**Ordinance Number: 1365-23, File Number: 19-24**

**RTA Tunnel Membrane Replacement- Addendum 3**

**NARRATIVE:** Addendum 3 contains the following:

Project Title: RTA TUNNEL MEMBRANE REPLACEMENT			
Sheet Title: TUNNEL REPAIR - REMOVAL DETAILS			
Designed: MSI	Drawn: MSI	Checked: LGW	Approved: LGW
Scale: AS SHOWN		Project No.: 198348	
Date: FEBRUARY 2024		Sheet: C-15

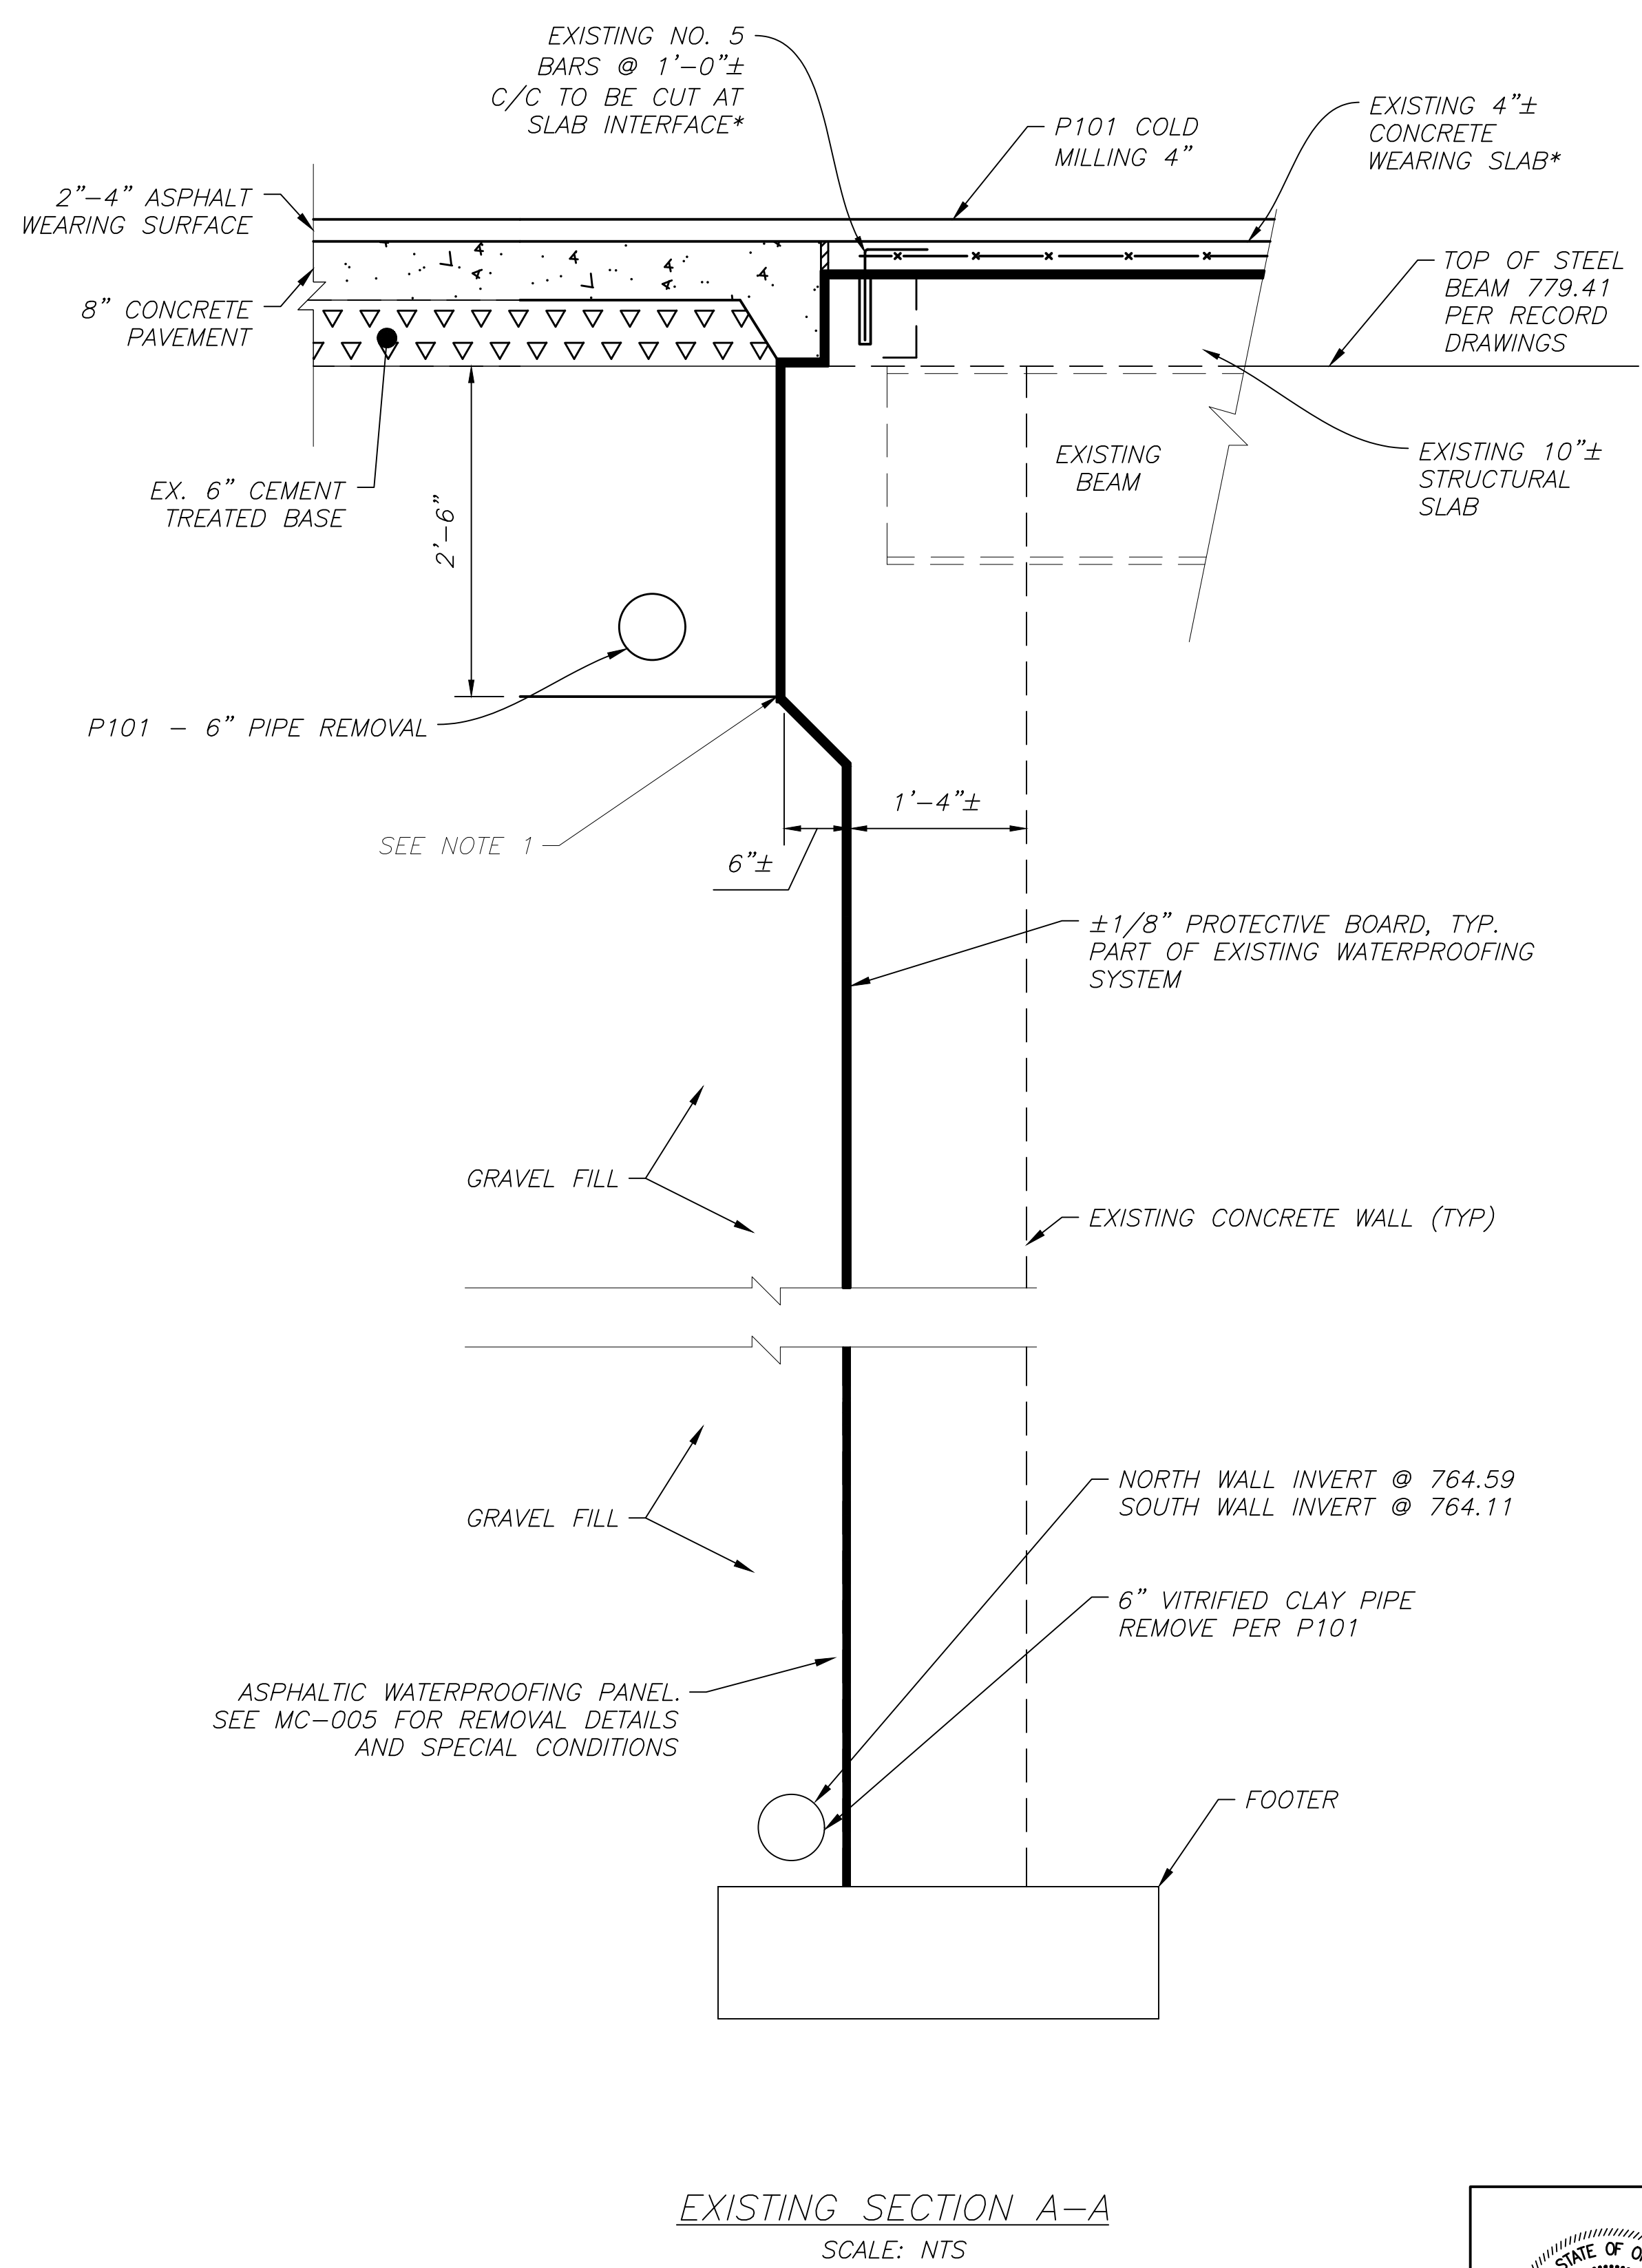
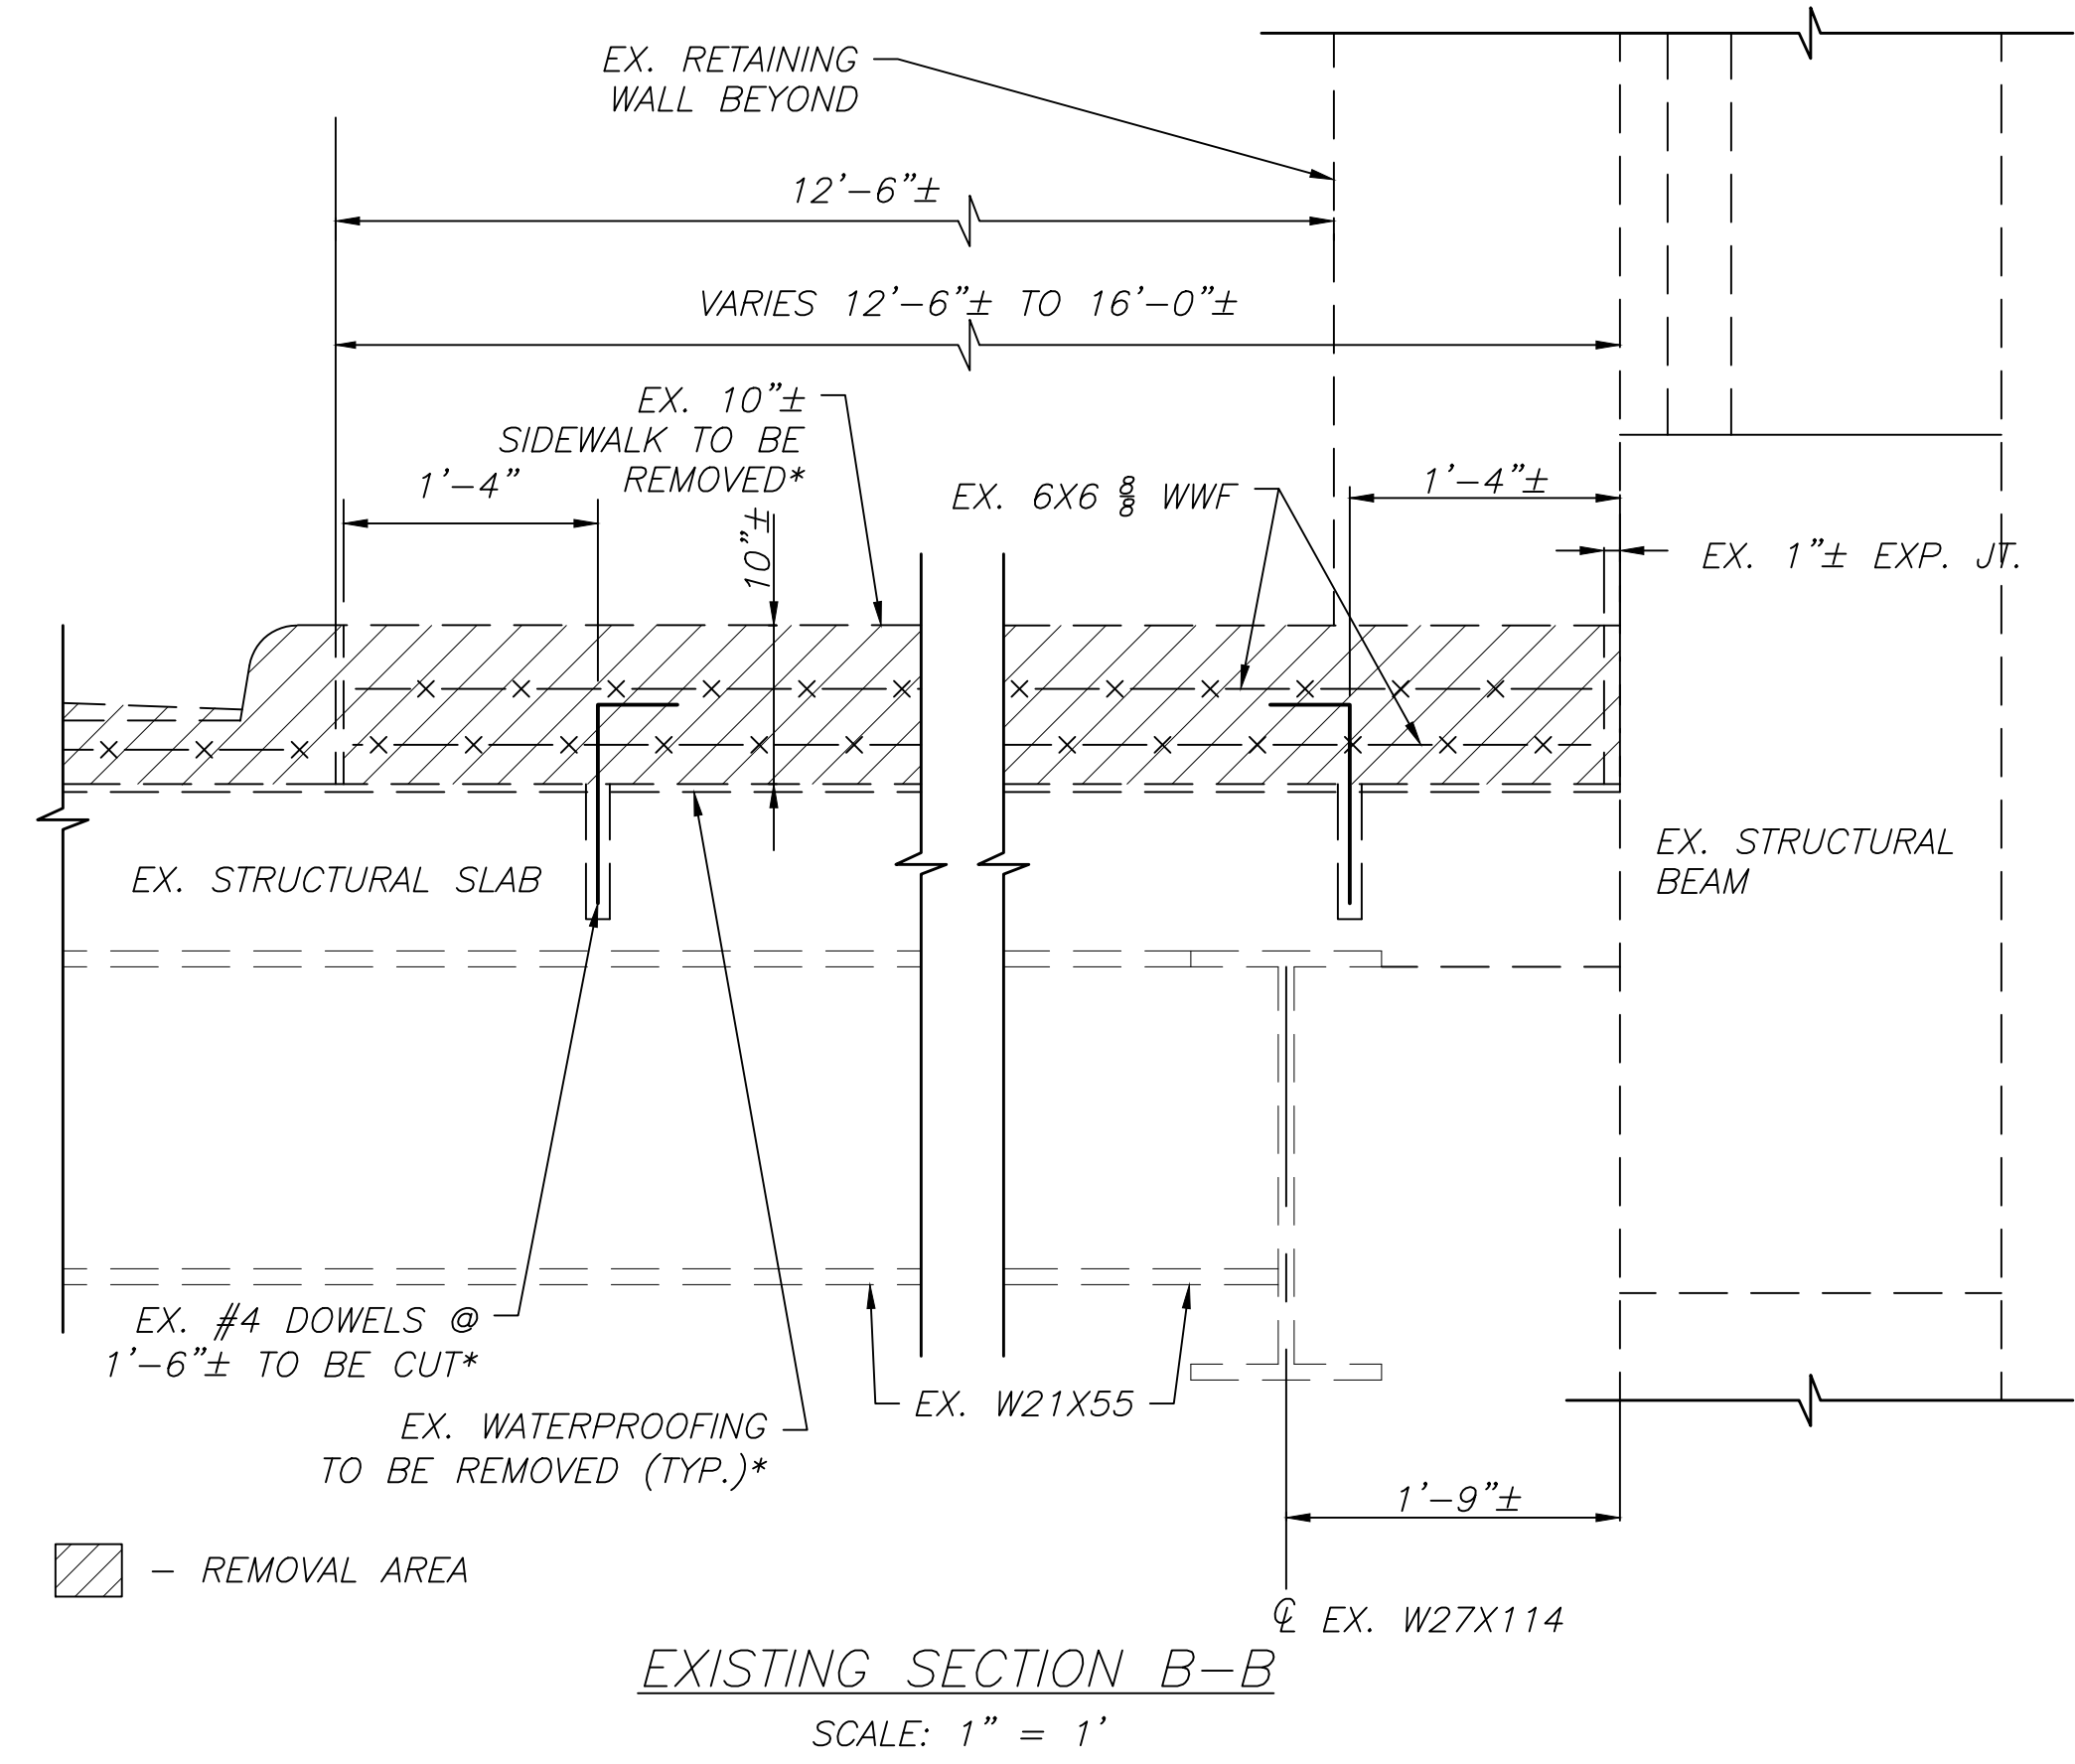
NOTE: ENTIRE SHEET REVISED FOR ADDENDUM A-3.
